PLANNING & HIGHWAYS COMMITTEE THURSDAY 15th JULY 2021 UPDATE REPORT.

The following update content should be read in conjunction with the published Committee Report.

Figure one – Initially proposed position of security gate

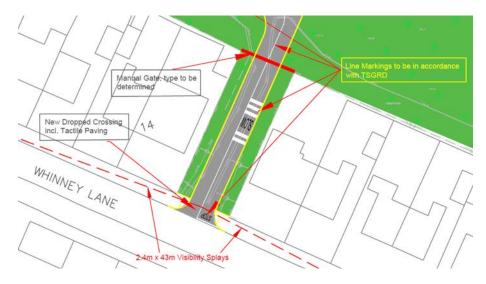
A **further condition** is recommended in order to agree the position of the security gates proposed for the new access point off Whinney Lane. Such a condition is necessary in order to ensure vehicles can turn around and egress the site in a forward gear when the gates are locked, and to prevent anti-social behaviour in relation to the access road between the two adjacent properties, when the school is closed. For reference, a zoomed extract of the area of the site in question is shown below in Figure one.

Notwithstanding the submitted details shown on the approved plan 'LPS-HWAYS-001 – Revision D', and prior to their installation, a scheme relating to the precise location of any required gates at the Whinney Lane access point shall have first been submitted to and approved in writing by the Local Planning Authority. The development shall thereafter be implemented in strict accordance with the approved scheme, unless otherwise agreed in writing.

REASON: In order to ensure vehicles can egress the site in a forward gear when the access gates are locked, in the interests of highway safety, and to comply with the requirements of Policy 10 of the Blackburn with Darwen Borough Council Local Plan Part 2, Site Allocations and Development Management Policies (Adopted 2015).
